AB Mart Fashion Wear Ltd (Extension)

786, Kakil Sataish, 13/3, Mudafa Purbopara, Tongi, Gazipur.

16 July 2025

2. Observation:

Observation-01: Inconsistencies in the design report & material strength. (Extension Building)

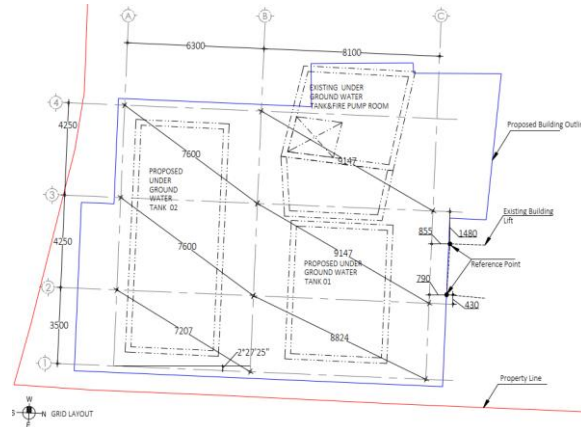
Description: Inconsistencies were found in the design report.

1. Design rebar strength is considered 500 MPa, but 420 MPa grade is used in construction.
2. The number of concrete cylinder tests does not meet the frequency of testing requirements of the BNBC 5.12.1
3. Framing system considered SMRF, but no detailed calculation was provided.
4. In the column review chapter, it is mentioned that columns are strengthened 100 mm on four sides with additional rebar. But no remedial drawing was found on-site.
5. The number pile provided in the pile adequacy check is not match the drawing.

The building engineer is required to assess the design and prepare the design report as per BNBC 1.9 and material strength from the in-situ testing.
